DEVIATION REQUEST AND DECISION FORM

Project Name :	Sterling Ranch Sand Creek Channel Construction Drawing Review CDR 20-4
Schedule No.(s) :	5227301021, 5233309027, 5228000030 & 38, 5233301001 5233301016 &17
Legal Description :	See Exhibit B – Legal Description

A deviation from the standards of or in Section **ECM section 3.3.3 Open Channel Design Standards** of the Engineering Criteria Manual (ECM) is requested for the Sand Creek Channel Design – Low Flow Channel Bottom Width.

Typical Channel Cross Section

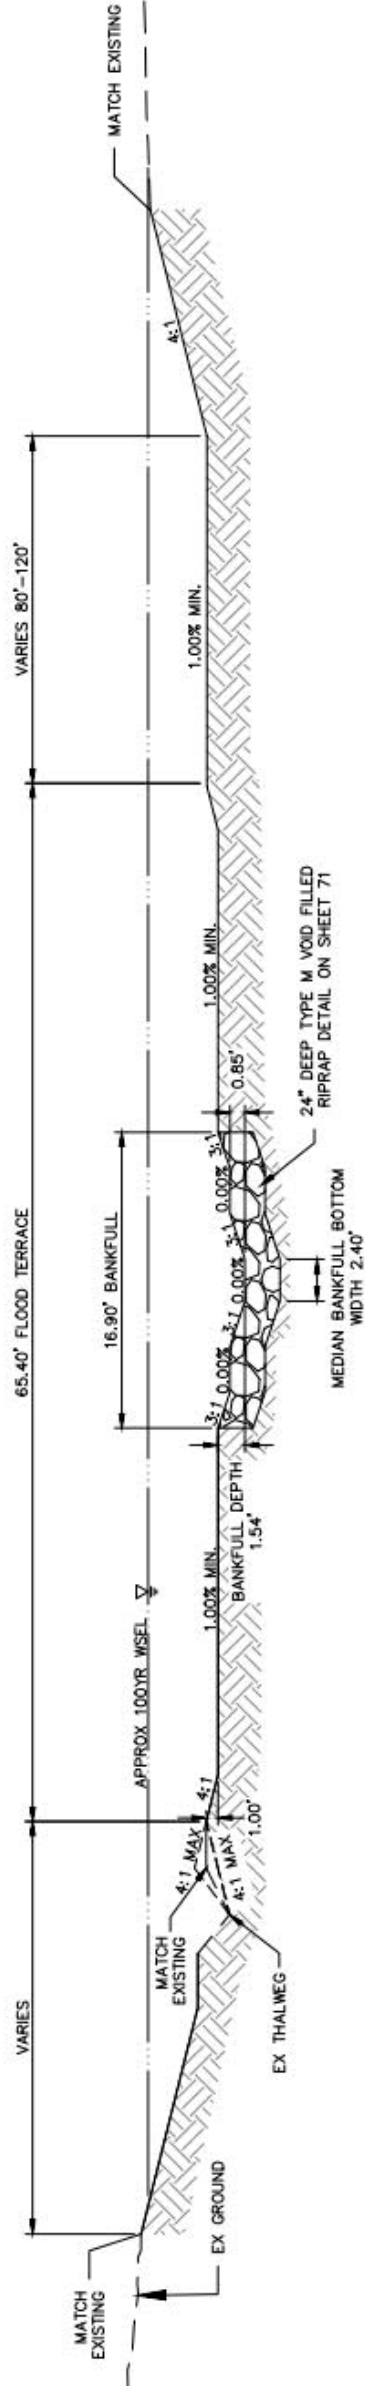
See Exhibit A for a representation of the “geomorphologist recommended” low flow channel cross section along with additional DCM 1 criteria excerpts.

The proposed low flow channel bottom width in the Sterling Ranch Sand Creek design is approximately 2.4 feet wide. The low flow channel is armored with 24” deep type M void filled rip rap.

The geomorphologist's reasoning for the smaller low flow channel cross section was that base flows in this reach of the channel are a fraction of the ECM criteria and a low flow channel sized to meet criteria would eventually cut its own low flow section for base flows. By using a narrower multi-stage section within the bankfull, dense vegetation can establish itself, particularly along the inner berm. This densely vegetated section should require minimal maintenance.

Maintenance of the low-flow channel shall be by the Sterling Ranch Metro District.
